## **SUBMISSION: DRAFT MAMRE ROAD DEVELOPMENT CONTROL PLAN**

This submission has been prepared by Urbis Pty Ltd (**Urbis**) on behalf of Pazit (**the landowner**), in response to the release of the draft Mamre Road Development Control Plan which is on exhibition from 10 November 2020 to 17 December 2020. The landowner welcomes the opportunity to comment on the draft Mamre Road Development Control Plan (**draft DCP**) and commends the Department of Planning, Industry and Environment (**DPIE**) on finalising the planning for the Mamre Road Precinct. It is recognised that the draft DCP is the last remaining planning document required to facilitate delivery of employment land within the precinct. Therefore, it is critical to ensure the DCP facilitates the right balance of planning controls to enable investment in the precinct.

Figure 1 Road Network Plan

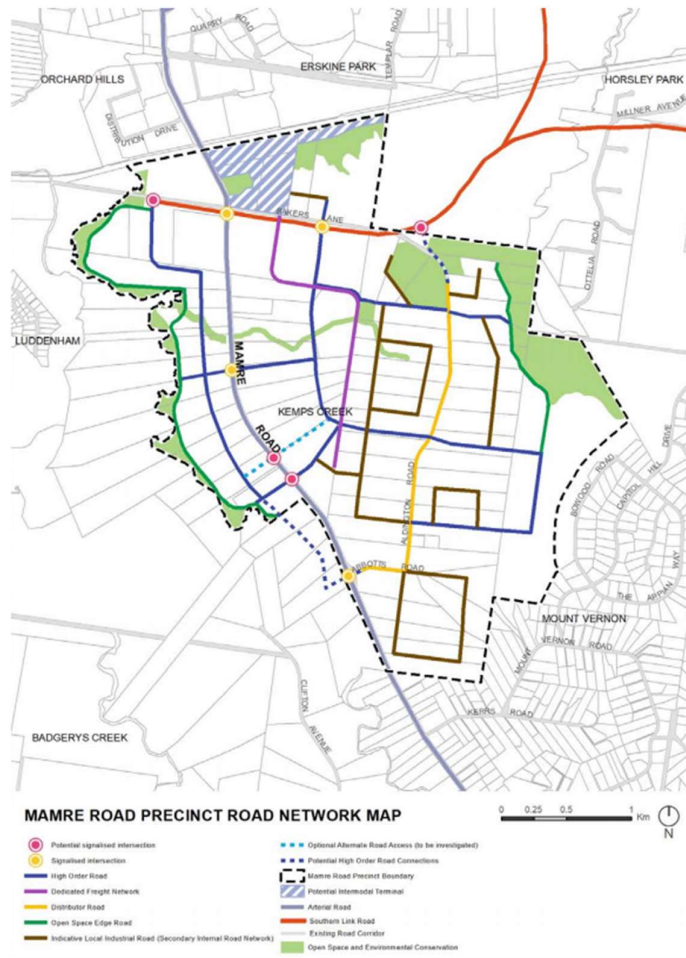
The Road Network Plan identifies Aldington Road as a key north-south Distributor Road, which will service landholdings in the eastern half of Mamre Road Precinct. The identification of Aldington Road as a key distributor road in the precinct is strongly supported.

In addition to Aldington Road, there are lower order roads required to provide internal connections to higher order roads, such as Aldington Road, Mamre Road and Southern Link Road. These connections are extremely important to the site, as it is currently landlocked. The landowner supports the identification of the three connections across the site, including:

- Open Space Edge Road to the north
- High Order Road in the middle of the site and to the south.

It is essential these road connections are maintained to create a permeably road network within the site. The removal of one of these road connections will create an inefficient network and run risk at creating a backlog of traffic to and from the site. Therefore, it is critical for this alignment to be

3. **The identification of Aldington Road as a Distributor Road is supported, and must be retained.**
4. **The road network plan must be upheld and form part of the finalisation of the DCP. It is critical to ensure there are the three connections to and from the site to support permeability and minimise traffic backlog within the site.**
5. **The road network be reviewed and improved to provide an extension of Abbots Road directly to our landowner's site.**
6. **All current and future State Significant, regional and local development applications must be consistent with this Road Network Plan to ensure permeability is achieved across the precinct.**
7. **A control is needed requiring lots to be built to the boundary to prevent land locked lots being created.**

Figure 2 Proposed Road Network Plan

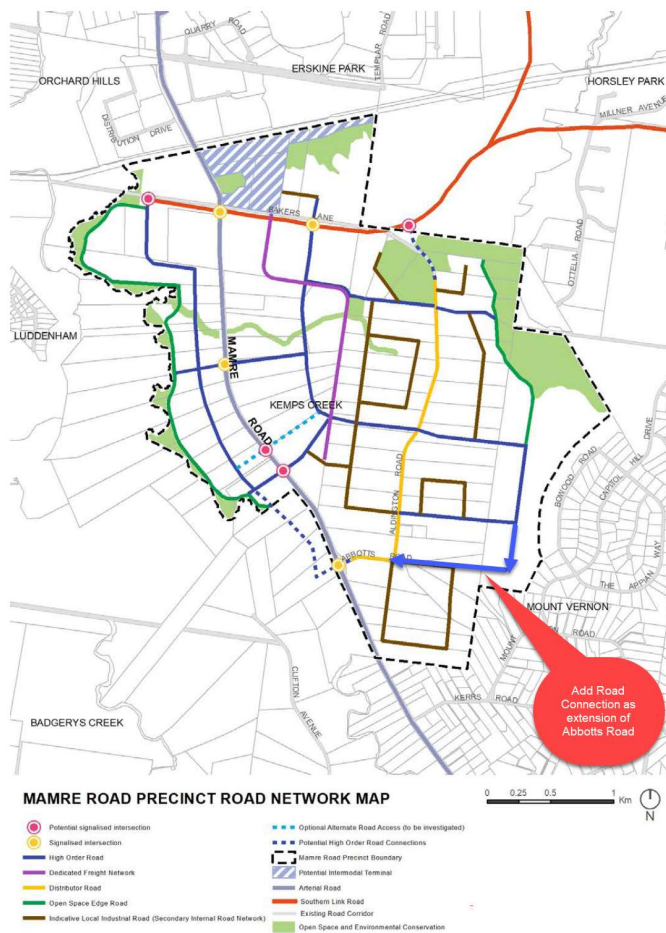
maintained and delivered through subsequent development application. We propose though that the southern road connection, shown as a collector road, would be better positioned further to the south to align with the extension of Abbots Road. This would provide a significantly improved road network, with the traffic from the southern portion of our landowner's site being able to directly access Mamre Road without having to access Aldington Road. This in our view would ease the traffic requirements on Aldington Road. This connection is shown below:

The landowner notes there is currently discrepancy between an existing State Significant Development Application to the west of the site, and this road alignment. It is imperative for this road network to be implemented across the development application stage to ensure connectivity across the precinct.

There should be a control which means that connecting roads should be constructed to the boundary to prevent a situation where land locked lots arise, avoiding a situation of a "ransom strip".
